I checked with Tim, and the 6-18-2013 Grading Plan is what was included in the approved Building Permit sets.

Senior Engineer
Planning - Hydrology
505-924-3994

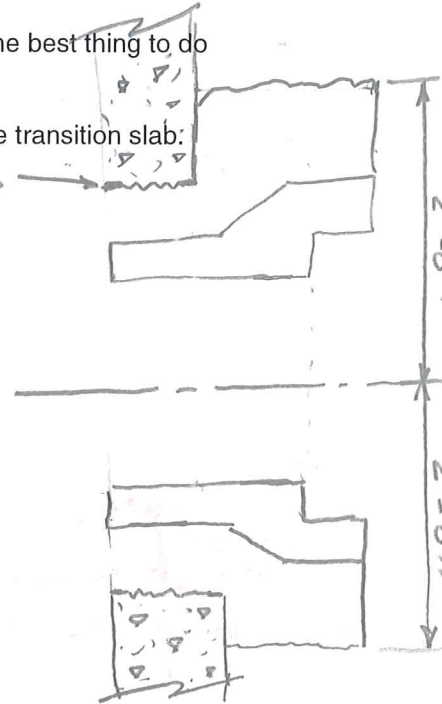
If the only change on the resubmittal is for the Mech Room slab grades, then the best thing to do would be to just red-line them onto the Certification Plan as-built.

FYI, I found our file, and am attaching a copy of the portion with the note for the transition slab:
